SUBJECT: Sealing The Fuel Filter Bowl Securing Bolt

APPLICATION: All Glasair II, II-S, Super II-S, and Glasair III aircraft. Also Glasair I aircraft which may have retrofitted to the Fram fuel filter assembly.

MODEL GLASAIR	ASSEMBLY NAME SERVICE BULLETIN 130	REVISION	DATE 1/10/95	VOLUME	PAGE 1 of 1
------------------	---------------------------------------	----------	-----------------	--------	----------------

FIGURE (1)

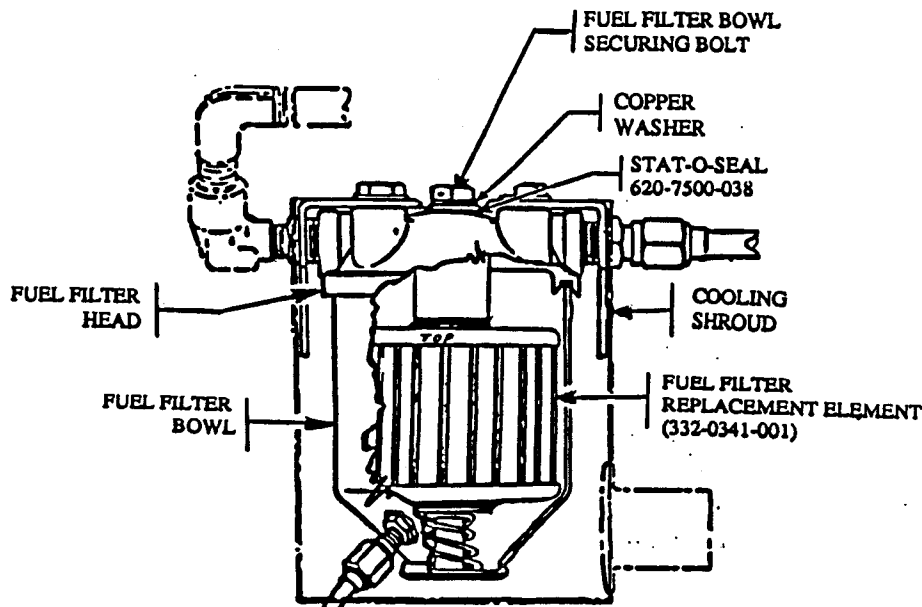
DESCRIPTION: Field reports from builders indicate that the Stat-O-Seal used to seal the fuel filter securing bolt, is subject to considerable twisting action when removing and installing the bolt. This eventually results in a less than perfect seal. The Fram fuel filter assembly, as supplied by Allied Signal, uses a copper gasket to seal the head of the bolt (called the Filter Head Capscrew on the Fram box) to the fuel filter head. In addition to the copper gasket, Stoddard-Hamilton has provided a Stat-O-Seal (620-7500-038) to ensure a positive seal at this point.

The Stat-O-Seal provided with the kit was expected to remain in service during several fuel filter element changes. In one case, a builder reported that this bolt seal had worn to the point that it would allow air to be drawn into the fuel lines by the suction power of the mechanical fuel pump but would not leak fuel under pressure. This resulted in loss of fuel pressure and loss of power.

REQUIRED ACTION: Stoddard Hamilton Aircraft requires that the Stat-O-Seal (620-7500-038) be replaced during every filter element change. Lubricate the seal with engine oil or light grease whenever the bolt is loosened. All fuel filter elements sold by S/H will now include a new Stat-O-Seal. Builders wishing to have extra Stat-O-Seals available can purchase them from the Stoddard-Hamilton order desk (360-435-8533).
